Model Name: KAT00 DIS

PCB NO: LA-5151P

## Schematic Document

### POITIER Montevina M96/M92

# Battery Connect/OTP

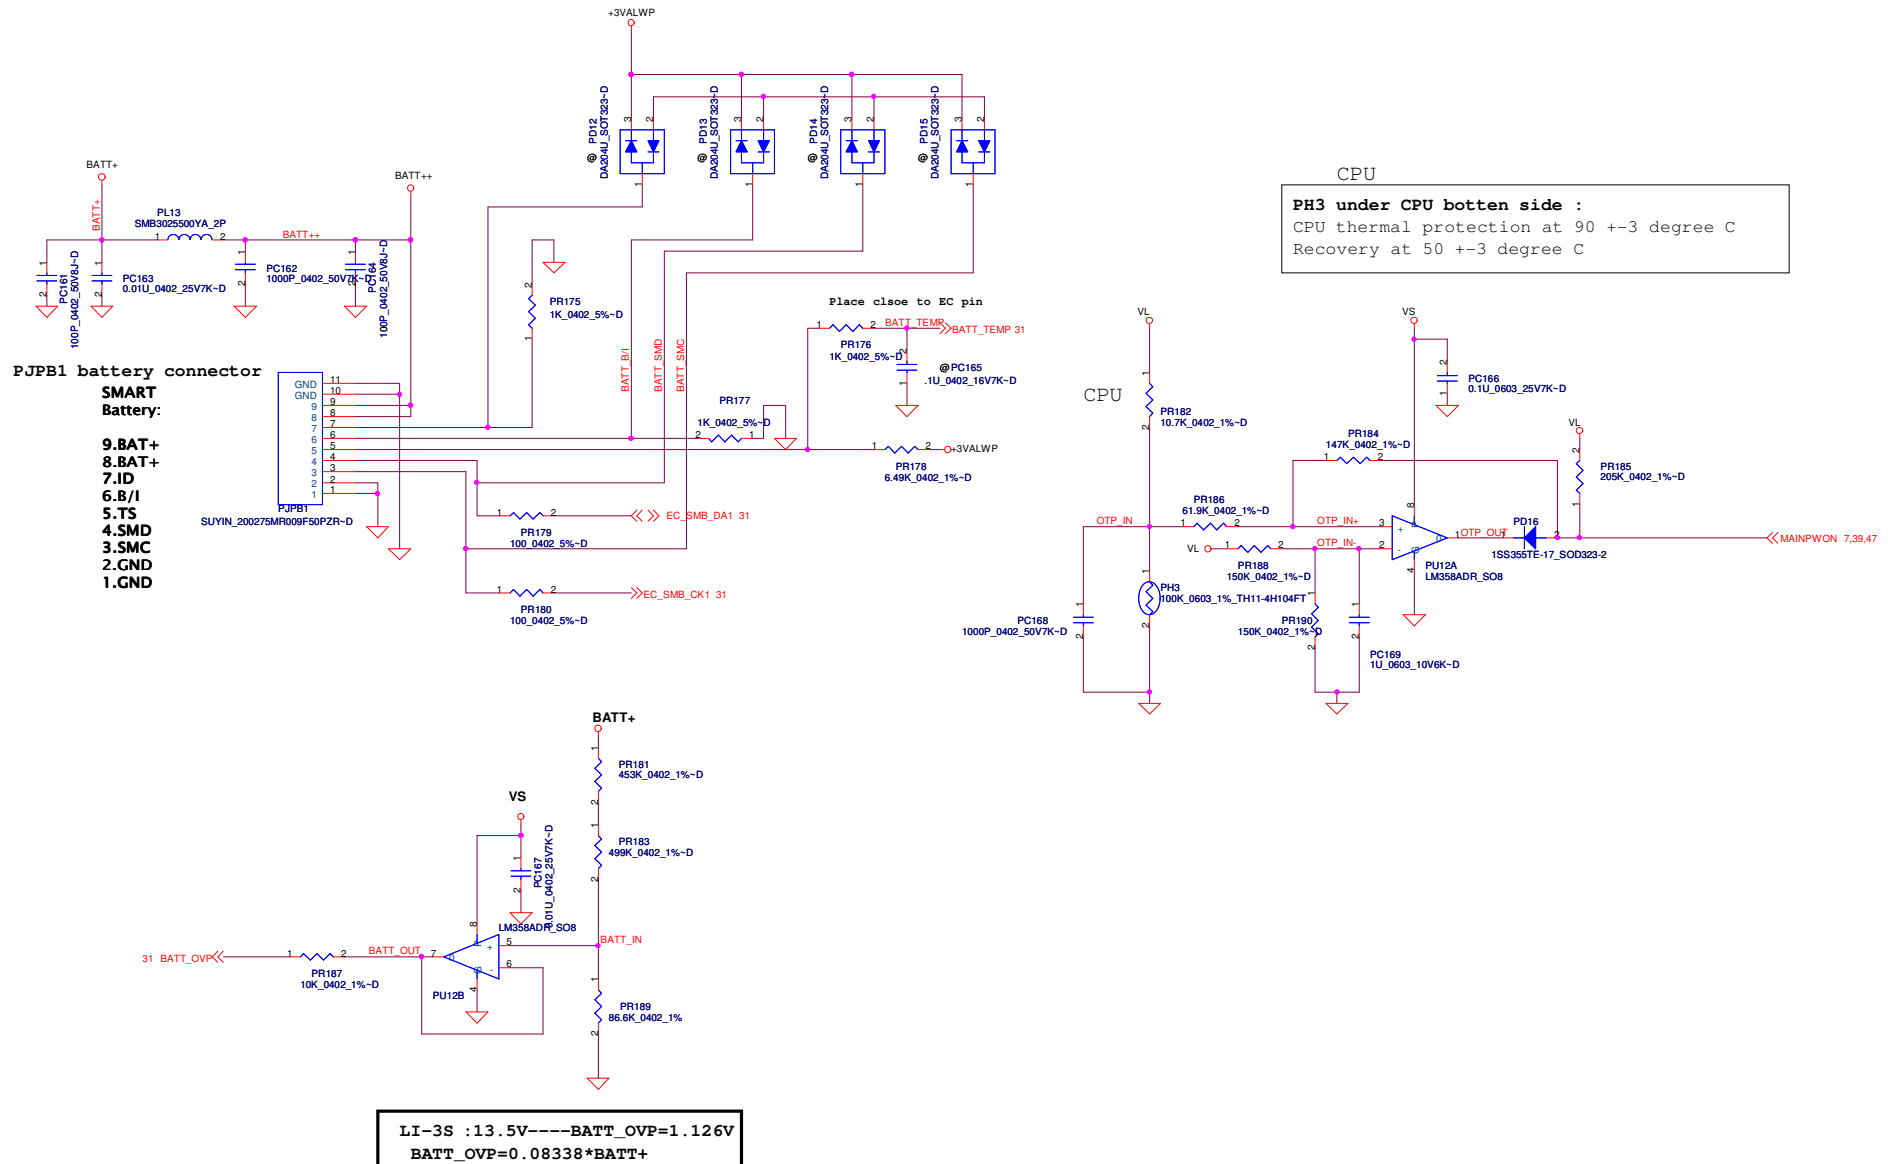
| Item | Page# | Title                          | Date  | Request Owner | Issue Description                                                        | Solution Description                                                                                                                      | Rev. |
|------|-------|--------------------------------|-------|---------------|--------------------------------------------------------------------------|-------------------------------------------------------------------------------------------------------------------------------------------|------|
| 13   | 52    | BATTERY CONN                   | 02/24 | Compal Mike   | Take off non-PSL Manufacturer:Panjit                                     | Change PQ43,PQ44,PQ45,PQ46 from P/N: SB000006800 (2N7002W T/R7 1N SOT-323) to SB00000B30L (PMF3800SN 1N SC70-3)                           | X01  |
